## Accessibility Design Review Report

**Project Title:** Forestville RSL Club and ILU development  
22 Melwood Ave, Forestville

**Job Number:** 24125

**Report Version:** 24125\_ADR\_v1.1

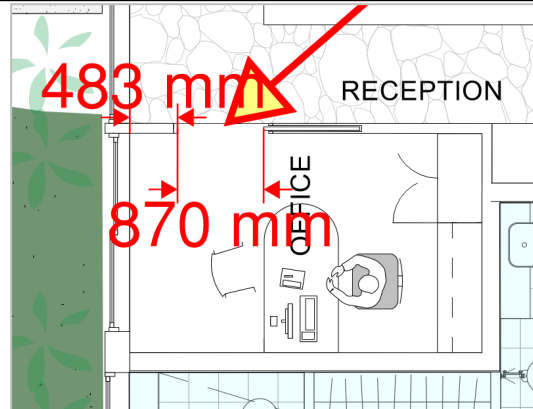
**Design Detail:**

Where sliding doorways are power operated, the latch-side clearance may be reduced to 0mm for a front on approach.

Ensure control buttons and card readers are located ≥ 500mm from an internal corner, over a level surface/landing and installed at a height between 900mm - 1250mm.

Ensure minimum 30% luminance contrast between doorways and surrounding surfaces is provided.

Existing first aid rooms require a contrast upgrade.

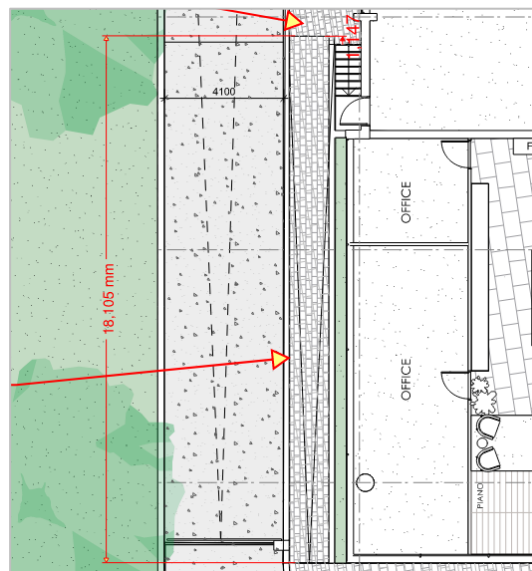
**Compliance Departure:**

The Basement 1 pedestrian ramp is indicated as a 1:14 gradient without a minimum 1200mm landing at 9m intervals. To be adjusted at CC stage.

**Design Detail:**

Ensure the pedestrian ramp joining the club GF level and B1 has a gradient of 1:24 or shallower. If not feasible, a series of 1:14 ramps with landings at 9m intervals or similar is also an option.

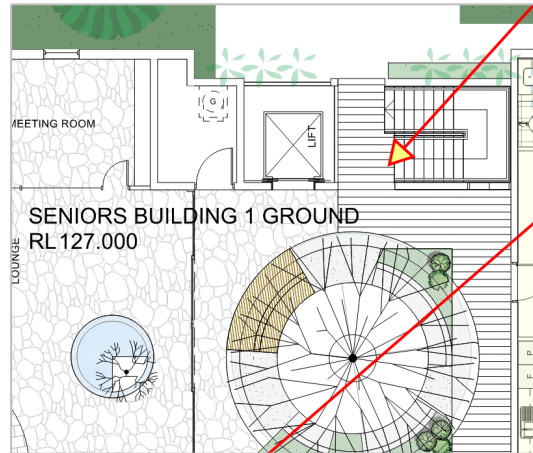
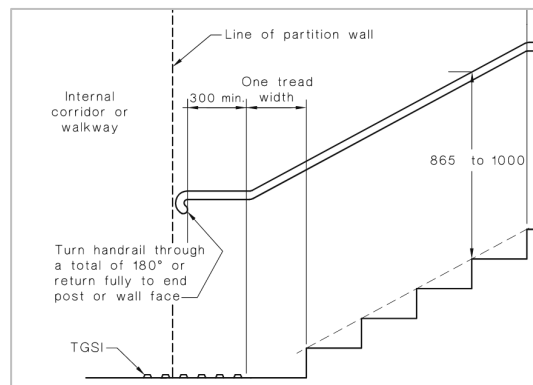
All non-fire-isolated stairways are required to comply with AS1428.1-2009.

Ensure all non fire-isolated stairways are provided with the associated accessible features such as handrails and TGSIs in accordance with AS1428.1 & AS1428.4.

Ensure handrail extensions are provided at top and bottom landings of non-fire isolated stairways and setback/protected by a wall or similar in accordance with AS1428.1-2009.

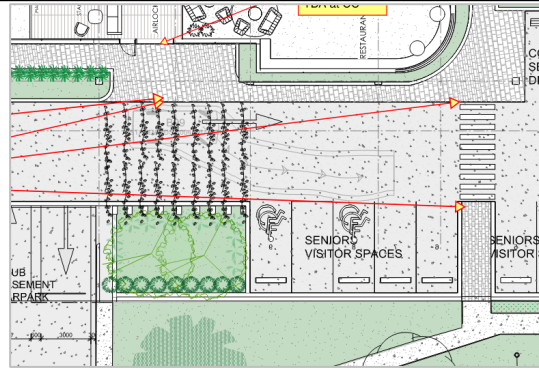
Ensure all integrated TGSIs (tiles) have a minimum 30% luminance contrast to the ground surface they are fixed to.

Ensure TGSIs are provided to non fire-isolated stairways and ramping between 1:14 to 1:20.

TGSIs are required at every stairway/ ramp landing where either 1 or both handrails are not continuous. Either provide continuous handrails or TGSIs at all landings with a discontinuous handrail.

Confirm where any overhead obstruction is provided below 2m as these areas are required to be treated with either a barrier or TGSIs.

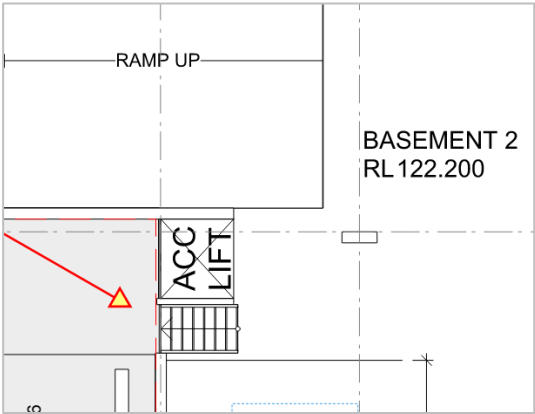
<b>DtS Provision</b>	<b>Comment(s)/Recommendation(s)</b>	<b>Status</b>
On an accessway, a series of connected ramps must not have a combined vertical rise of more than 3.6 m; and a landing for a step ramp must not overlap a landing for another step ramp or ramp.	The pedestrian ramp joining the club GF level and B1 will be assessed in greater detail at detailed design stage.	CoC
